NS7520 Errata

Part number/version: 90000352_L

NS7520 Hardware Reference

Part number/version: 90000353_C

UART CTS-related transmit data errors

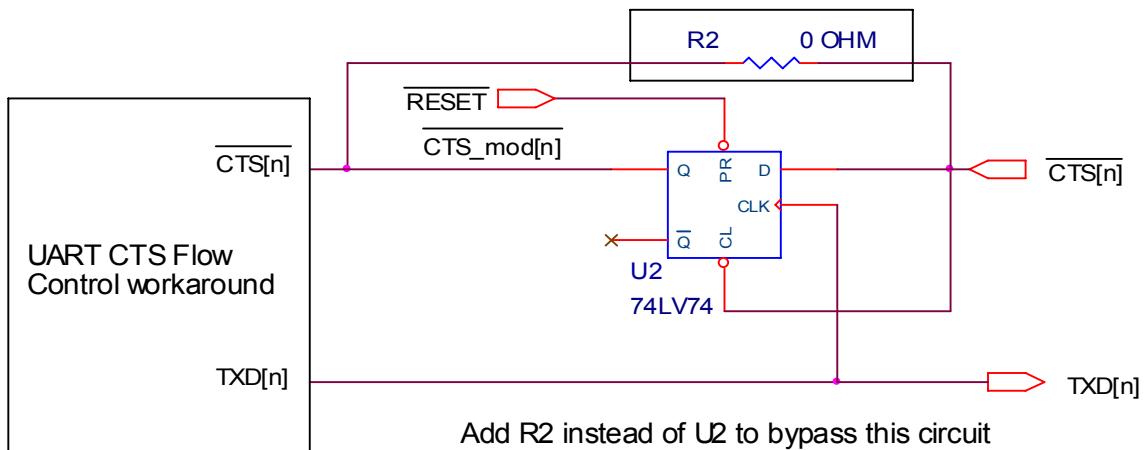
A problem occurs when the CTS flow control signal is de-asserted during the BCLK that begins processing a new character. This problem causes the previous character to be re-transmitted instead of getting the next character from the transmit FIFO.

- Modify these bits in Serial Channel Control register A:
 - Set the CTSTX bit (bit 23) to 0 to disable hardware-controlled CTSTX.
 - Set the ERXCTS bit (bit 4) to enable the software CTS signal change interrupt.
 - Update the serial transmit ISR to handle the CTS signal change.
- Non-DMA mode: Because FIFO can hold up to eight lines of 4 bytes each, the maximum skid rate will be 32 characters.
- To reduce the maximum skid rate to eight characters, the software is changed to write 1 byte in each line.
- In DMA mode, the skid rate can be up to the number of bytes transmitted in 1 tick.
- The serial monitor thread is changed to handle the missing CTS interrupt.

For each UART, externally clock the CTS signal with the Txd_n signal to guarantee that CTS will not be seen de-asserting at the start of a character.

NS7520 clock speed erratum

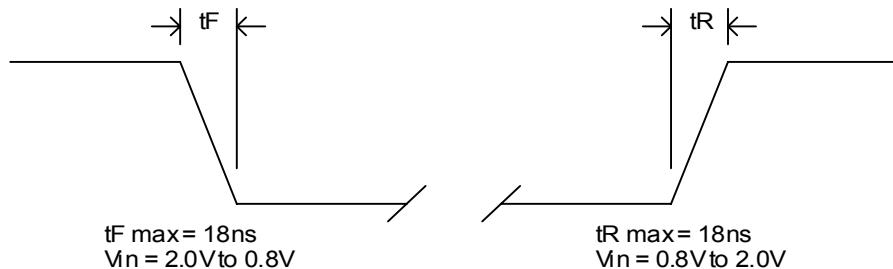
When the NS7520 is configured to use the PLL clock generator, the system clock can come up at 1/2 the configured frequency, or at a higher frequency – usually 64 MHz.

When the PLLTST and BISTEN signals are set high with the SCANEN signal low, the PLL clock generator should produce the system clock based on the code it reads on address signals A[4:0]. On occasion, the system clock is either 1/2 the frequency or greater than the configured frequency due to the internal PLL circuitry not being properly reset.

Ensure that the RESET source has adequate fall/rise times and is free from glitches and ringing to prevent 64 MHz or other higher frequencies. This example shows rise and fall timing:

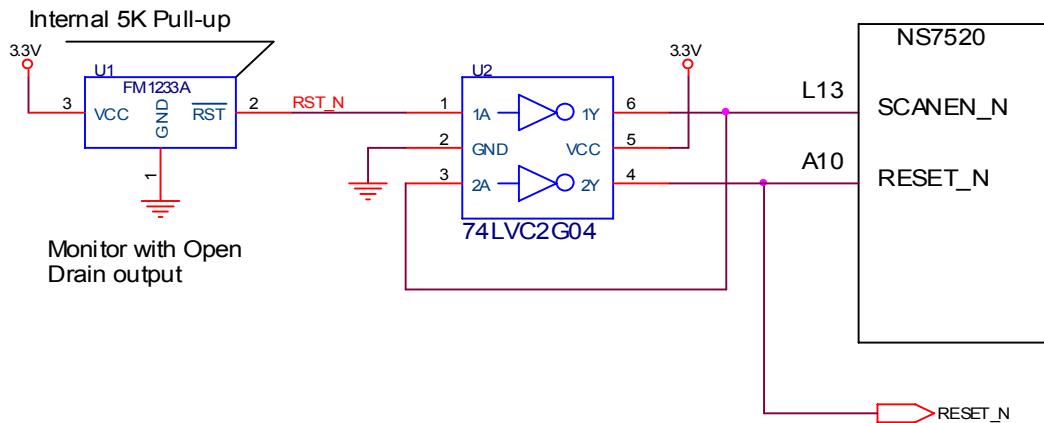
Invert the active LVTTL RESET_N signal and attach it to the SCANEN_N pin to prevent the 1/2 BCLK failure. The maximum delay (inverter propagation delay plus the etch delay) between pins A10 and L13 must be less than 8ns. This next example shows the SCANEN_N inverter with active TTL monitor:
